Chevrolet Dealer Service Technical Bulletin

67-T-18

Subject: INOPERATIVE CAMARO HEADLAMP DOORS

FIGURE ① INSTALLING MOTOR TO DOOR MECHANISM

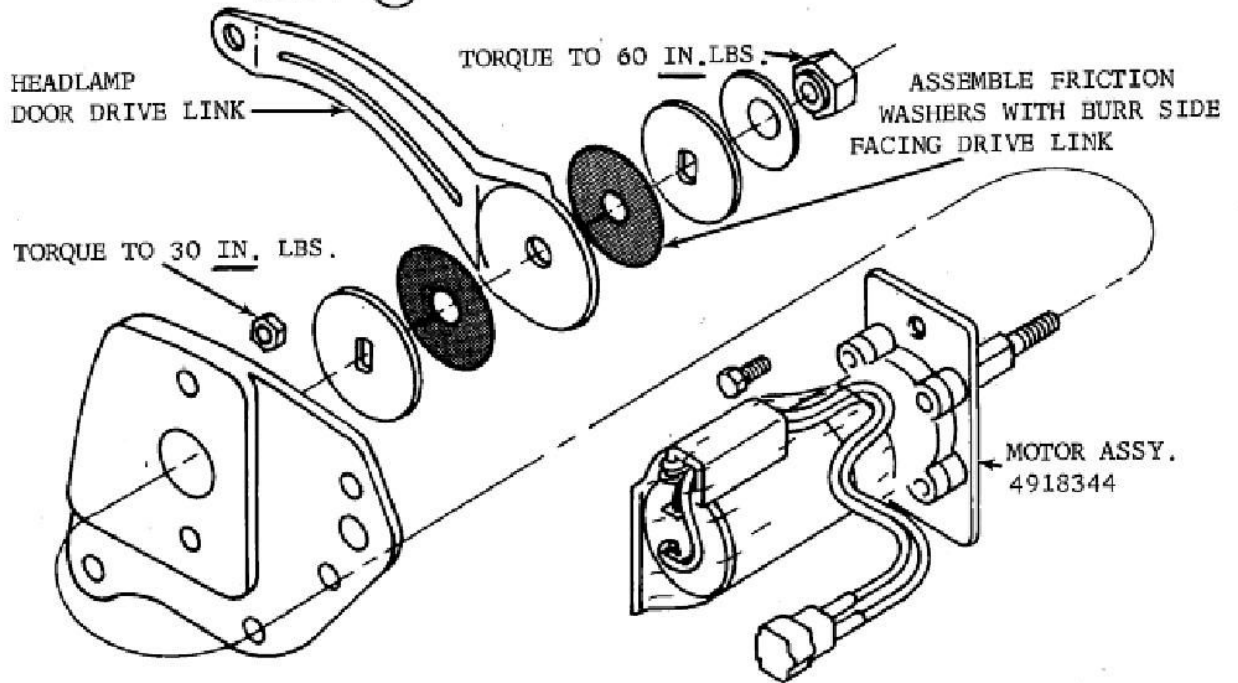
1. Install new headlamp door motors No. 4918344. Assemble as shown in Figure 1 and torque the clutch plate retaining nut as shown to insure proper operation of the drive motor.

NOTE: DO NOT remove the plastic bag in which the motor is partially enclosed.
